SUBJECT: PRESENTATION MATERIALS FROM THE FEBRUARY 22, 1994 MEETING ON
AP600 DESIGN CHANGES

PRESENTATION
TO
UNITED STATES
NUCLEAR REGULATORY COMMISSION

AP600 Design Changes

MONROEVILLE, PA
FEBRUARY 22, 1994

PRESSURIZER HEATER BREAKER ARRANGEMENT

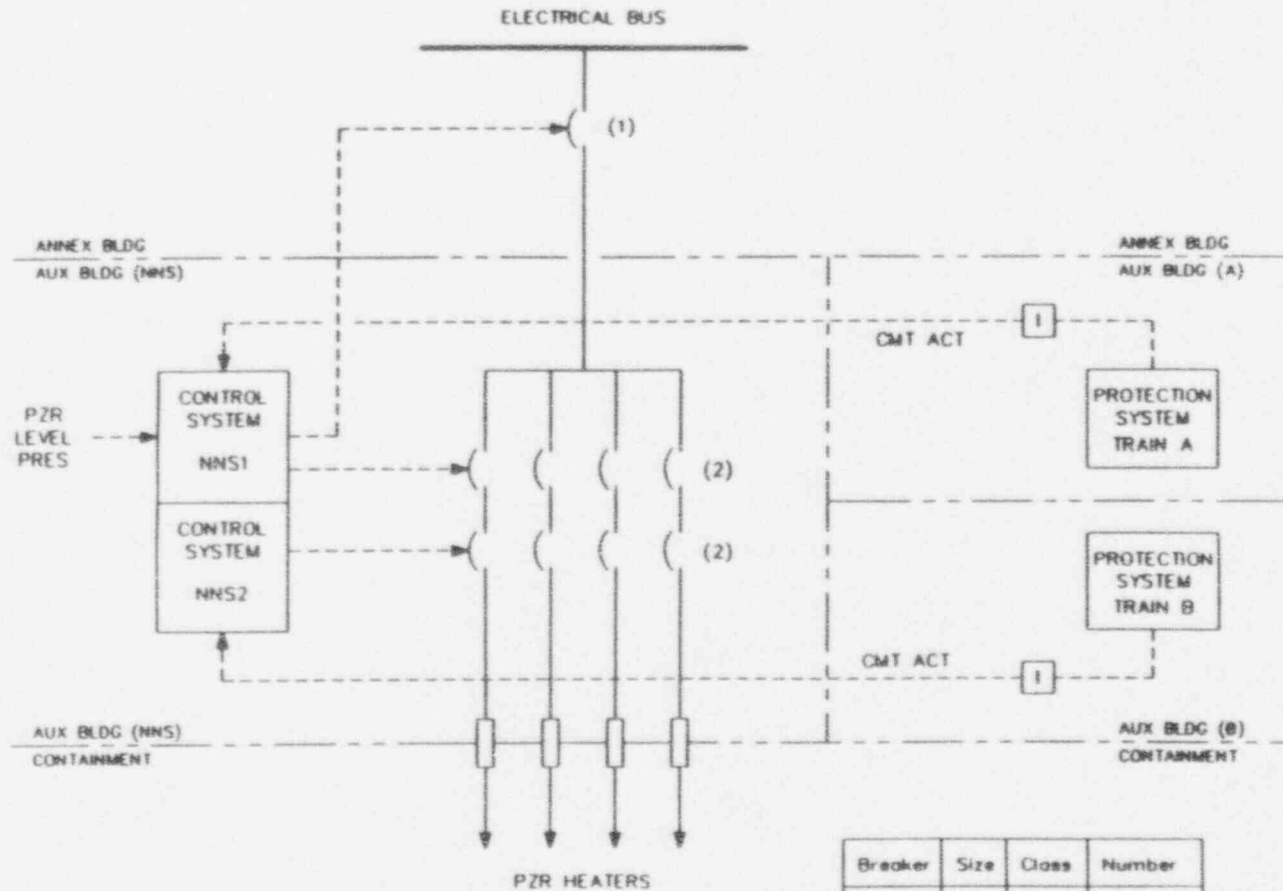
PRESSURIZER HEATER LOGIC CHANGE

- SSAR: no block on CMT actuation
- Revised: block pressurizer heater operation on CMT actuation
 - Nonsafety related automatic block (3 way redundant)
 - Local manual block provides backup

- Increases margin to ADS and SG overfill during SGTR and pressurizer overfill during non-LOCAs
 - No operator action required on best estimate basis
 - With DBA assumptions, auto heater block can fail
 - Long term heater operation be blocked
 - Operators can open breakers locally

PRHR HEAT EXCHANGER SYSTEM SKETCH

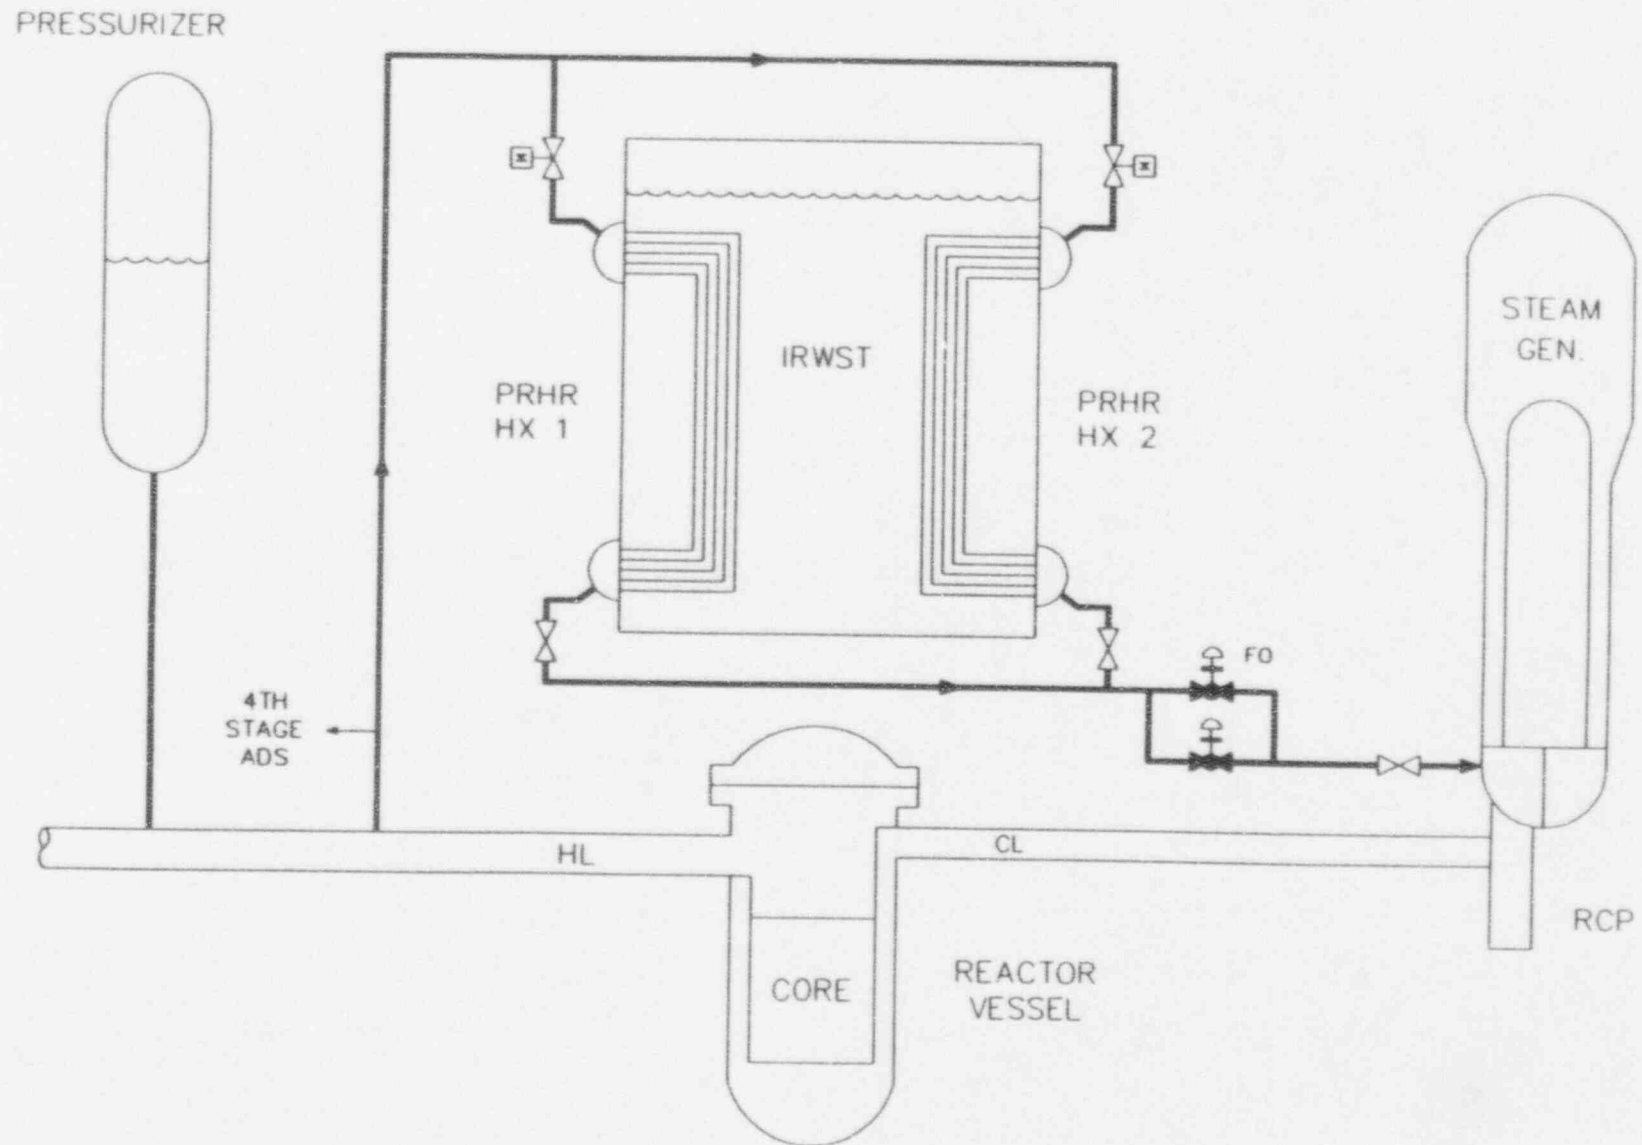
PRHR HEAT EXCHANGER INLET VALVE CHANGE

- SSAR: inlet to PRHR HX has common MOV and individual manual valves
- Revised: inlet to PRHR HX has individual MOVs
 - Power removal not normally required

- Improves reliability of PRHR heat exchanger
 - Chance of blocking both heat exchangers reduced, no common valve
- Reduces chance of violating PRHR heat exchanger tech spec
 - During IST of PRHR heat exchanger outlet control valves, inlet MOV closed
 - SSAR design; failure of 1 valve causes plant shutdown
 - Revised design; 2 failures needed to cause plant shutdown

Nuclear Power Transient

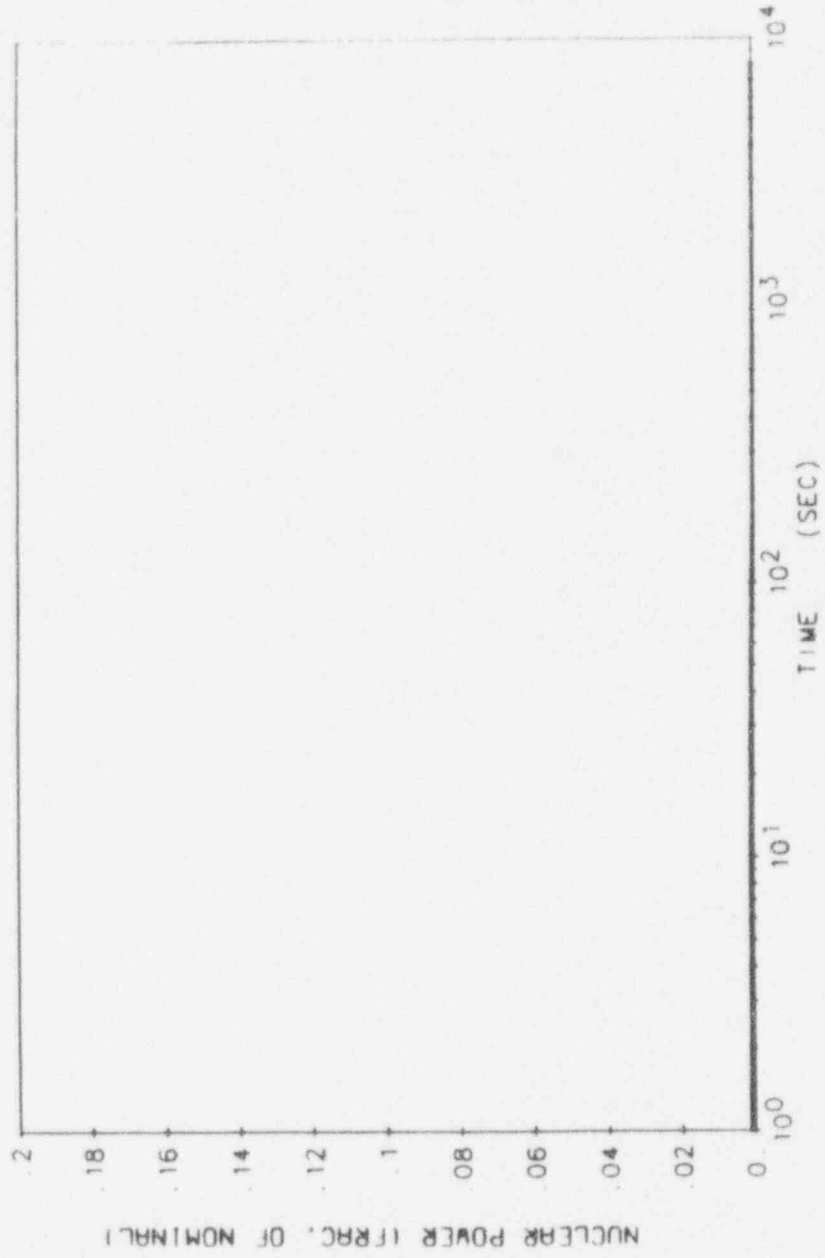
- **PRHR heat exchanger actuation signal change**
 - Limiting steamline break cases
 - SG water level typically falls to low level setpoint
 - Pressurizer water level falls initially; restored by CMTs and/or accumulators
 - Conservative core response cases start PRHR at time zero - maximizes cooldown & negates design change effect on analysis

- **PRHR actuation change: no effect on limiting steamline break core response analysis**

FIGURE 1
COMPARISON OF PRIMARY TO SECONDARY BREAK FLOW

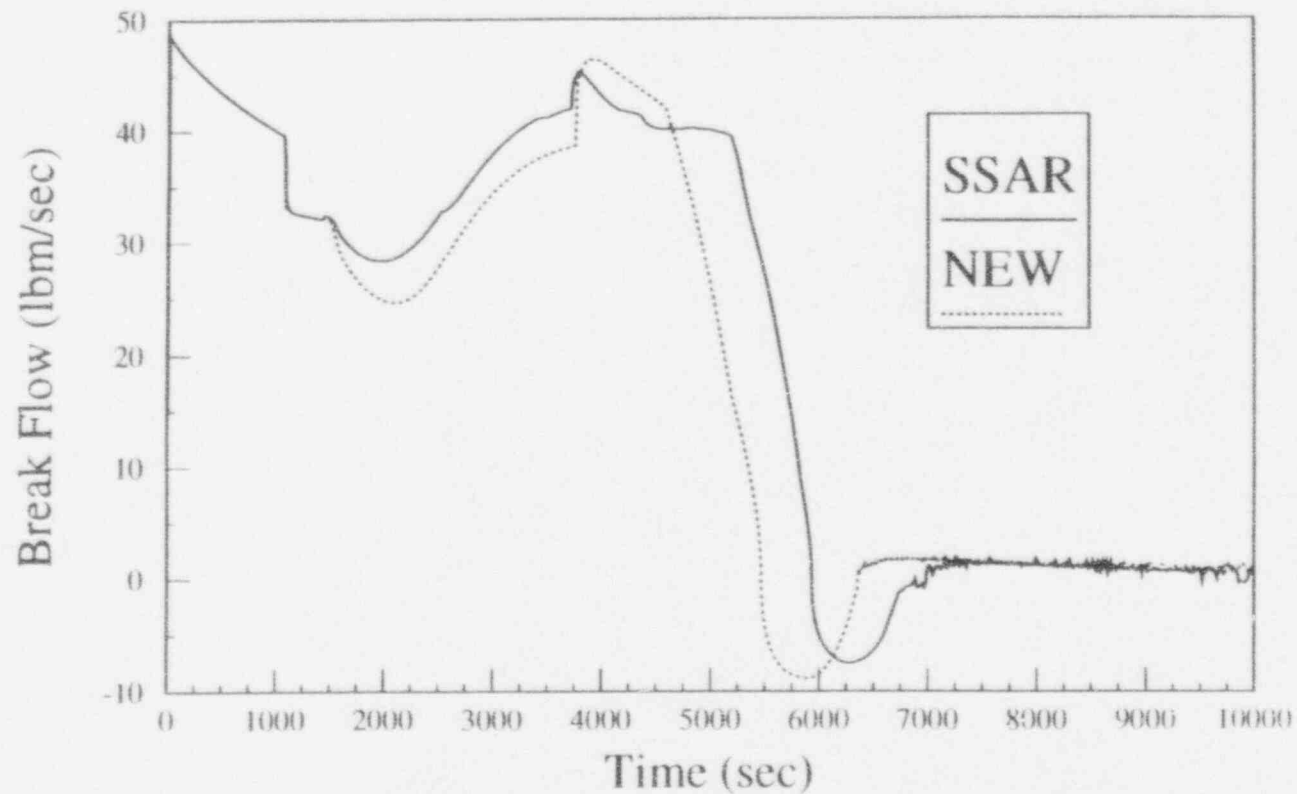
- SSAR: INITIATES PRHR ON HIGH SG LEVEL SIGNAL
- ANALYSIS HAS BEEN PERFORMED WITH REVISED PRHR INITIATION LOGIC
 - PRHR initiation on CMT actuation signal
 - Analysis assumptions and single failure identical to SSAR analysis
 - Transient progression not significantly changed
 - Sequence of events compared in Table 1
 - Break flow transient plots compared in Figure 1
 - Benefit for offsite dose analysis due to reduced break flow and steam releases
 - Integrated break flow and steam releases compared in Table 2
